Re: Wellman Dynamics Corporation – RCRA Facility Identification No. IAD065218737
Administrative Order on Consent (“AOC”), EPA Docket No. RCRA-07-2003-0167
Submission of Final Current Conditions Report

**SUBJECT: Response to Comments on Current Conditions Report for
Wellman Dynamics Corporation
RCRA Facility Identification No. IAD065218737
Administrative Order on Consent (AOC)
EPA Docket No. RCRA-07-2003-0167
BT² Project #2631**

BT², Inc., is submitting this letter on behalf of Wellman Dynamics Corporation to provide responses to the comments you provided for the Current Conditions Report (CCR) for this site. The report was submitted on May 20, 2004. Your comments were provided to Wellman Dynamics Corporation in a letter dated May 10, 2005, which was received by Wellman Dynamics Corporation on May 16, 2005. Each of your comments is shown below in bold type followed by our response.

Figure 7
Potential Exposure Pathway Summary
Wellman Dynamics, Creston, Iowa

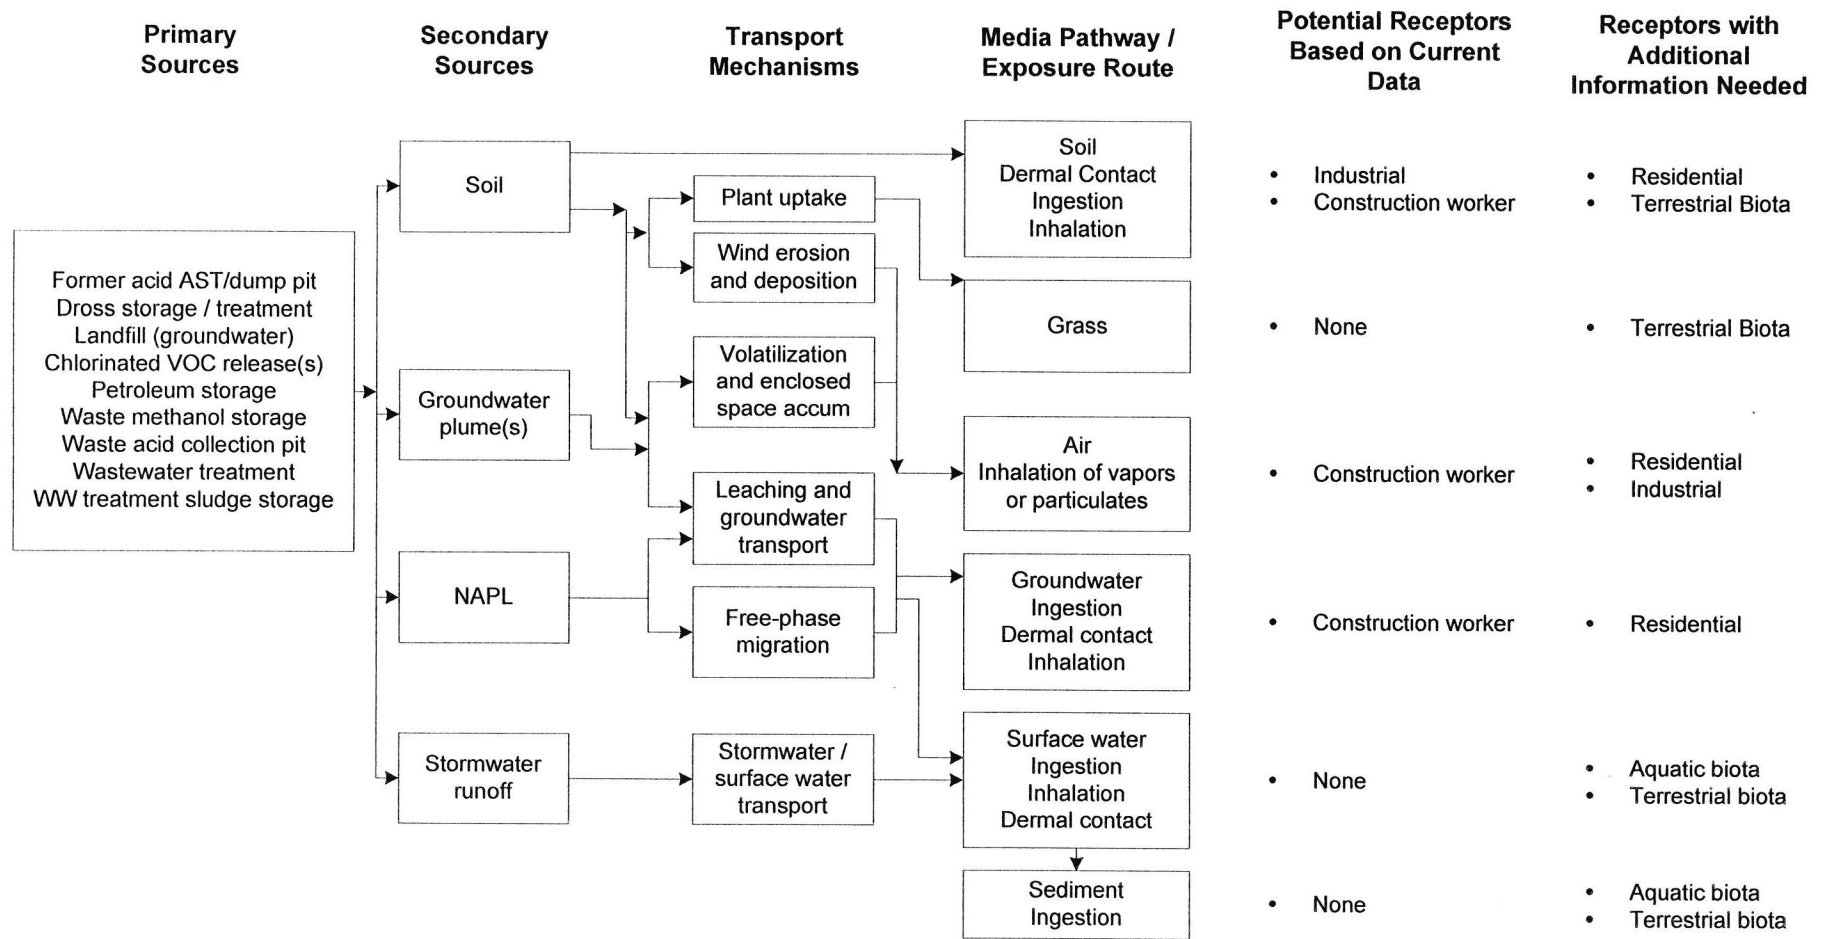
4. Page 16 and 28, Section 4.3.6 and Section 4.8.6, respectively: The Current Wastewater Treatment Sludge Storage Area (SWMU 2) and the Waste Methanol Drum Storage Area (SWMU 7) are not proposed for further investigation. The proximity of these SWMUs to site soils make them susceptible to releases of hazardous waste and/or hazardous constituents that may migrate to underlying groundwater. The close proximity of the two SWMUs should facilitate soil sampling for status confirmation. The Current Conditions Report must be revised to state that soil sampling will be performed as part of the RFI work plan and in accordance with the standard procedures and protocols.

We have modified the text in Section 4.3.6, Section 4.8.6, and Section 4.16 to propose soil sampling in these areas. We have also added these areas to the exposure pathway discussions in Sections 6.3.5 and 6.3.7 and revised the exposure pathway diagrams on Figures 7 and 11.

FIGURE 3
SHALLOW GROUNDWATER CONTOUR MAP
MARCH 2003
WELLMAN DYNAMICS CORPORATION
CRESTON, IOWA

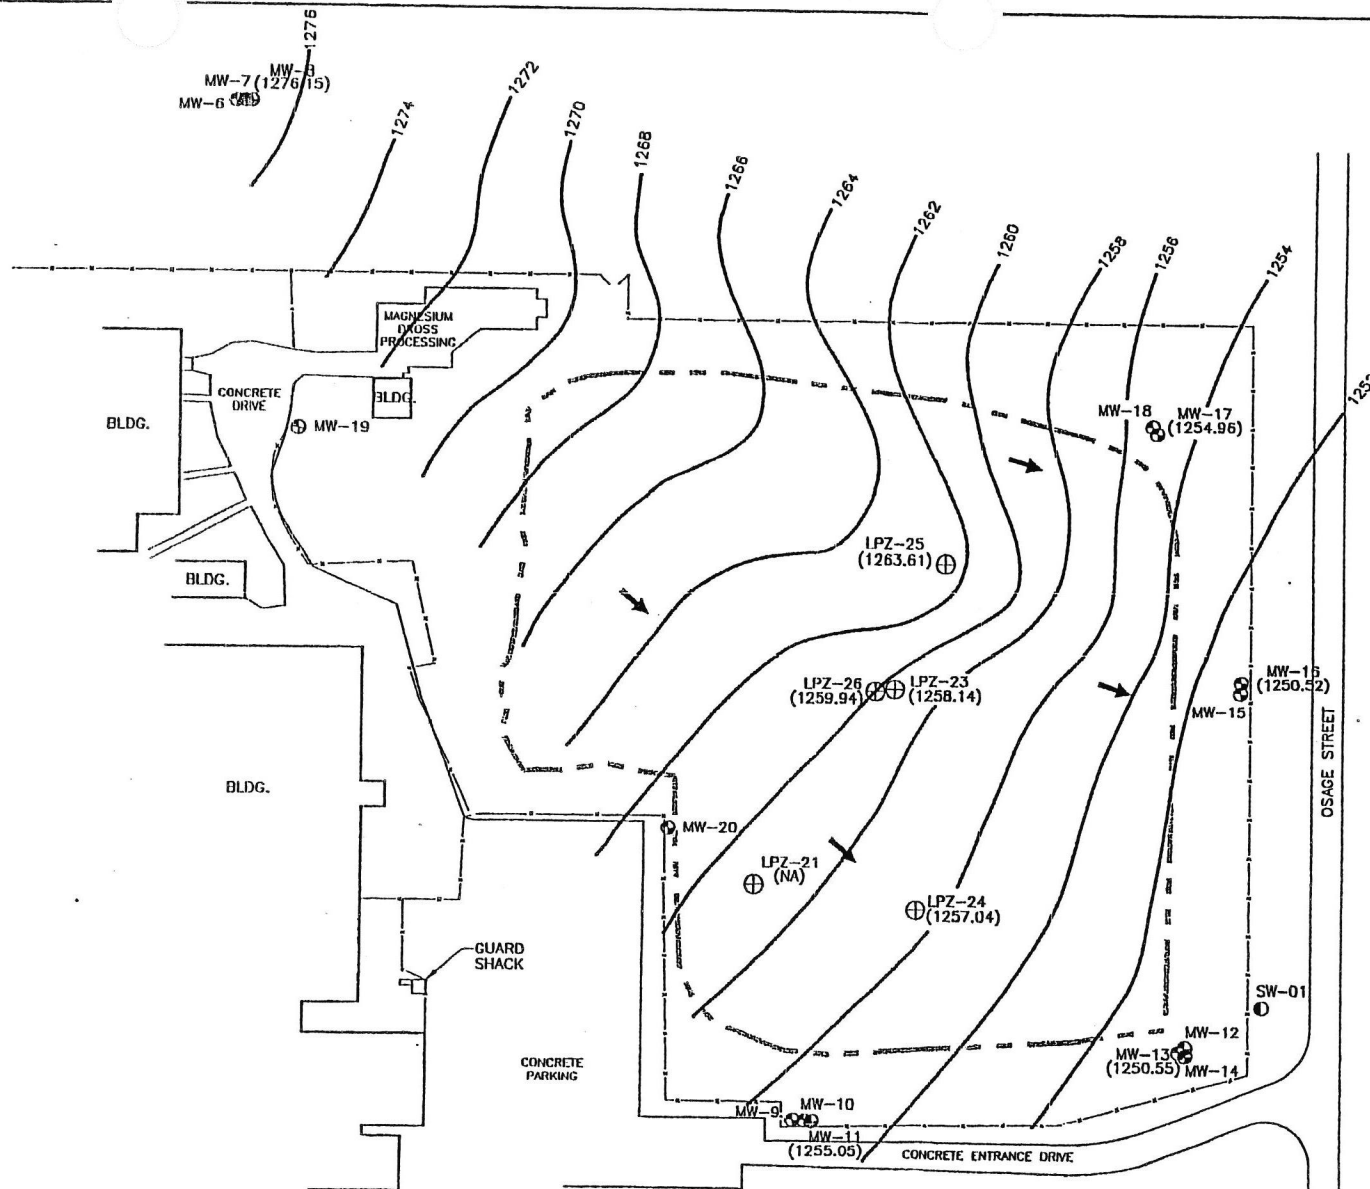
2. Page 10, Section 3.5, Site-Specific Geology and Hydrogeology: The local hydrogeology has not been fully characterized with respect to flow direction and extent of contamination. The need to fully understand the hydrogeology is imperative to completing the RCRA Facility Investigation (RFI). The absence of potentiometric surface maps and hydrogeologic profiles suggests that the monitoring well network should be evaluated thoroughly with respect to understanding contaminant transport and coverage. The Current Conditions Report should emphasize the need for further evaluation of these issues during the next phase of the corrective action process (i.e., RFI).

The flow direction at the site as determined by water table monitoring wells and leachate wells has been documented. Two water table maps which show the site groundwater flow directions to be from northwest to southeast at the site have been added to Appendix C. We agree that further work is necessary with respect to determining potentiometric surfaces, deeper groundwater flow, and extent of groundwater contamination. We have modified the text in Section 3.5 to indicate that further groundwater evaluation will be part of the RFI.
